DOCKETED	
Docket Number:	19-SPPE-05
Project Title:	Mission College Data Center SPPE
TN #:	232246
Document Title:	MCBGF Response to CEC Data Request Set 2, (60-63)
Description:	N/A
Filer:	Scott Galati
Organization:	DayZenLLC
Submitter Role:	Applicant Representative
Submission Date:	2/27/2020 12:10:18 PM
Docketed Date:	2/27/2020

RESPONSE TO CEC STAFF DATA REQUEST SET 2 (60-63)

Mission College Backup Generating Facility (19-SPPE-05)

SUBMITTED BY: Oppidan Investment Company

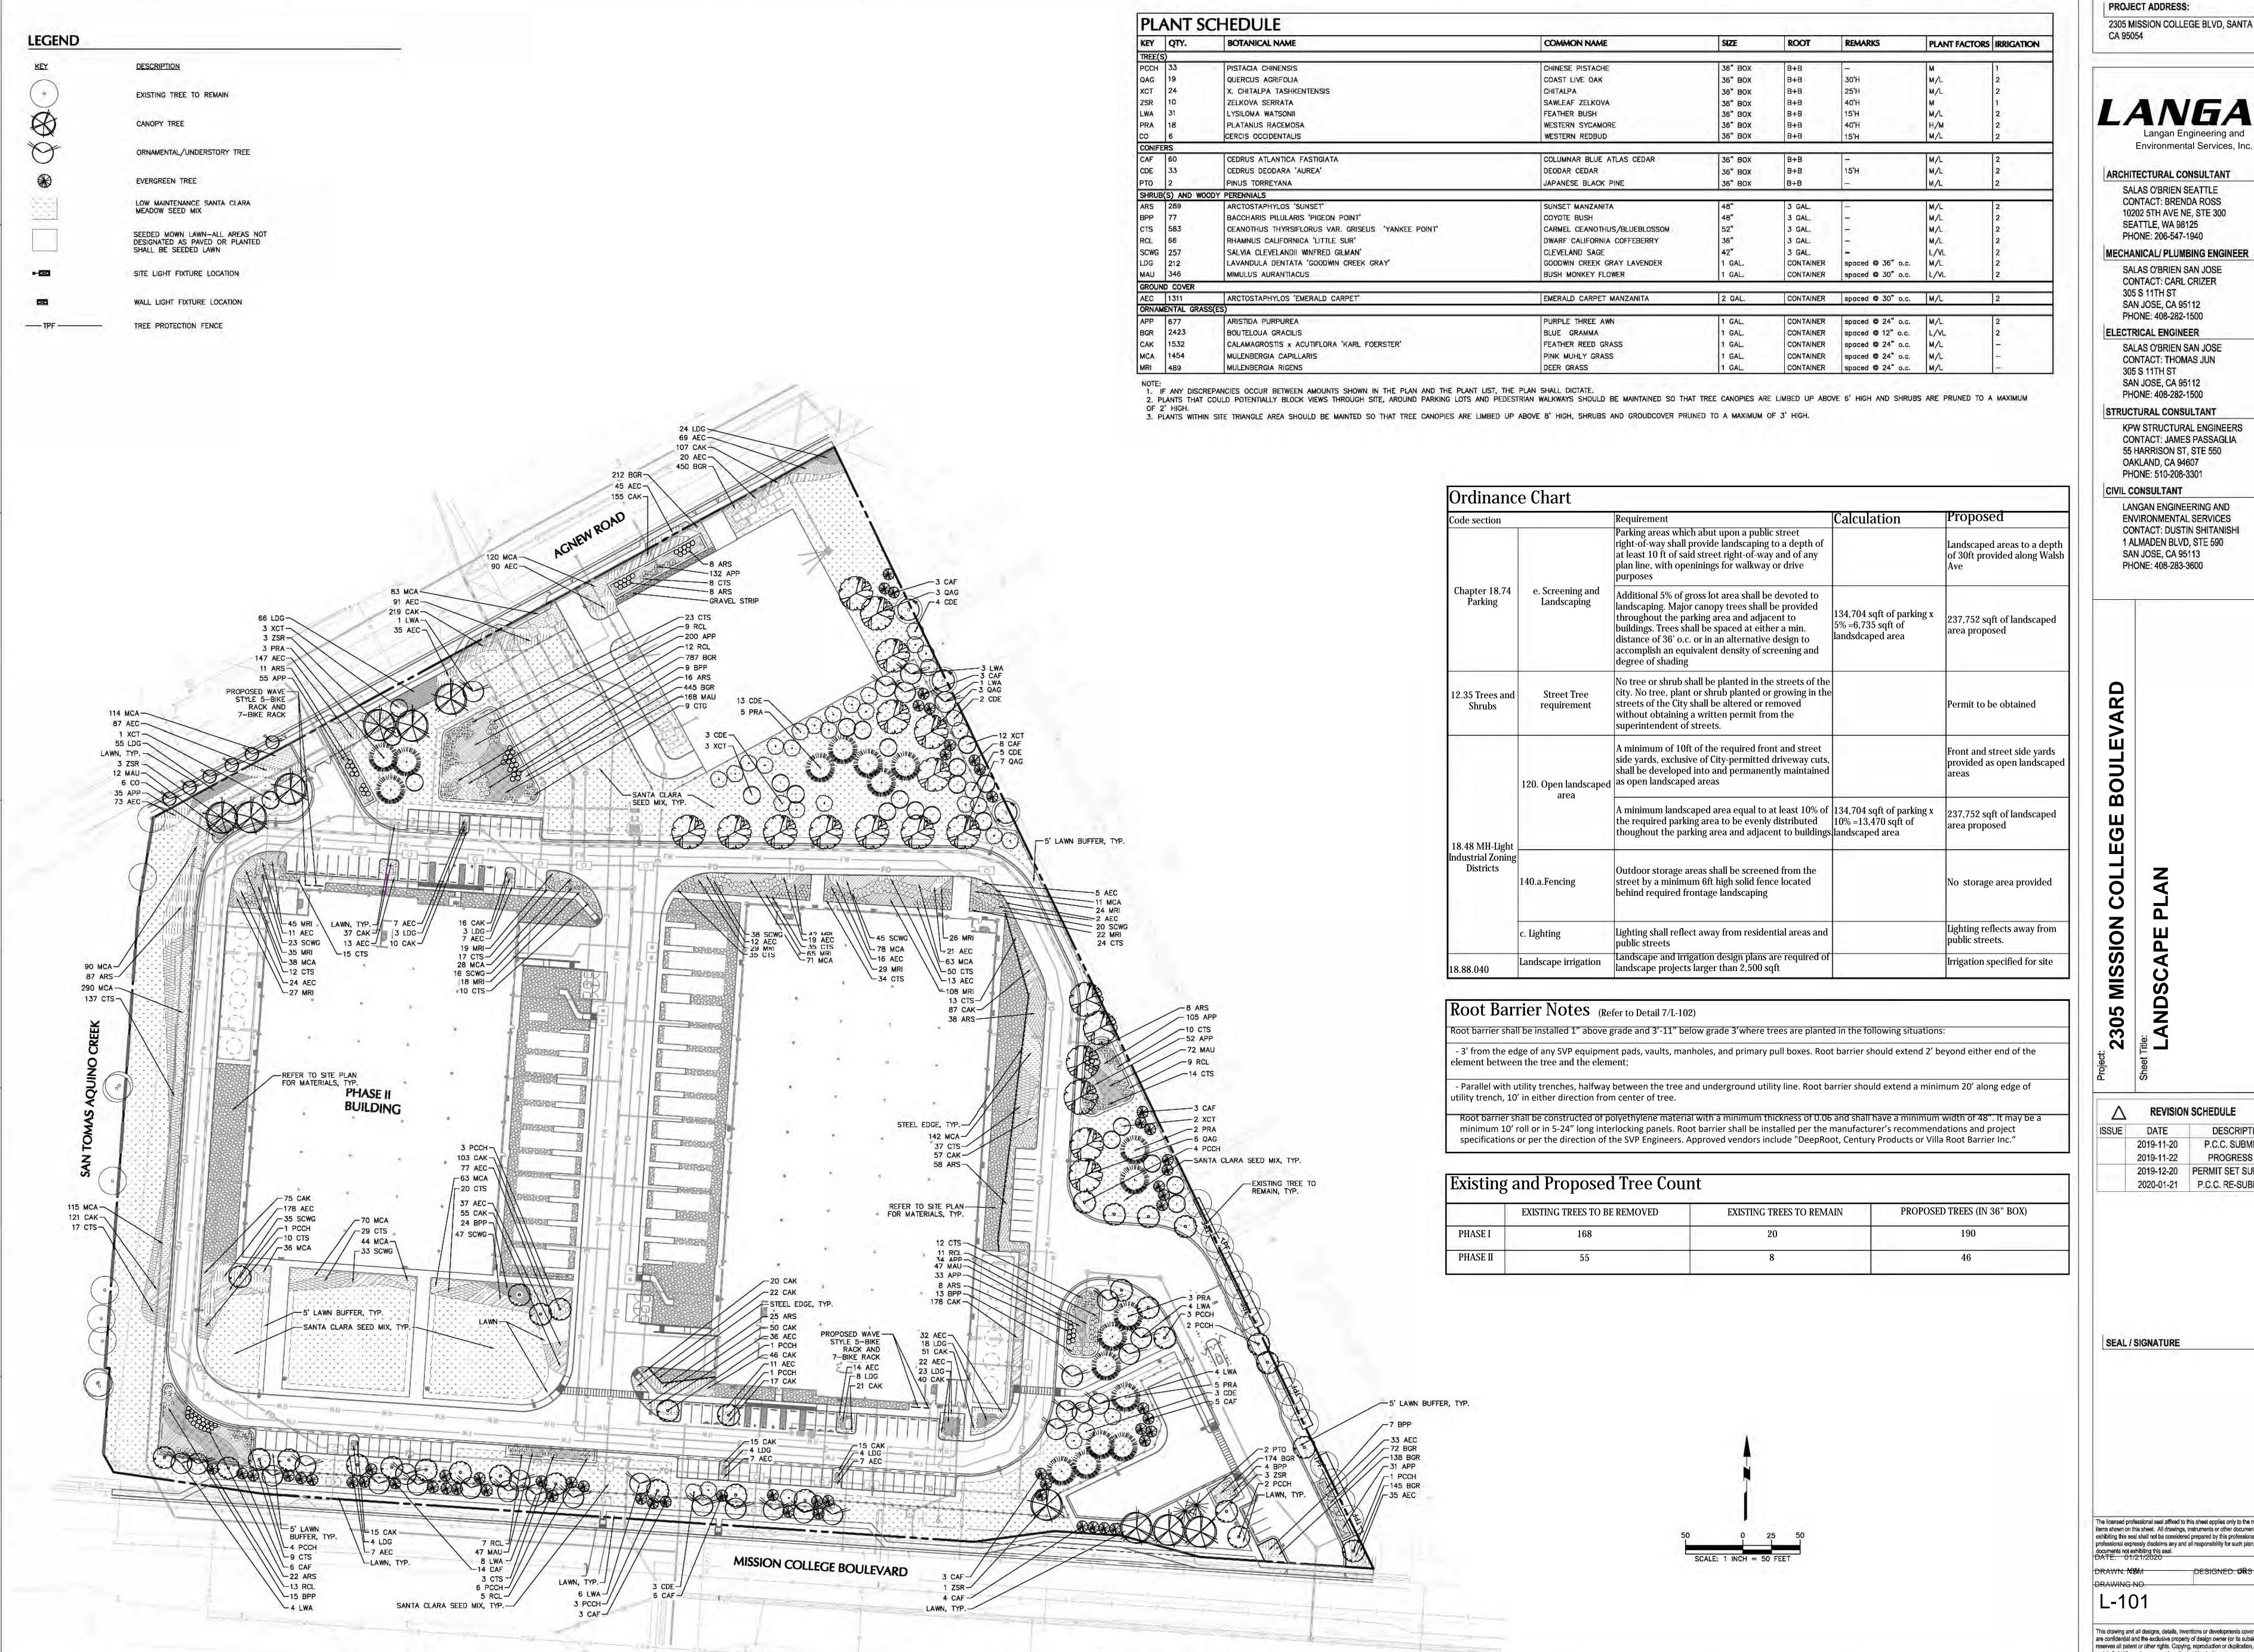
63. In its response to Data Request 54, the applicant stated that "[t]he MCDC will be interconnected to the SVP North Loop."

According to the SVP Transmission Overview available to staff, there is no North Loop. Please clarify which loop the MCDC would be interconnected to.

The MCDC will be interconnected to the SVP Northeast Loop.
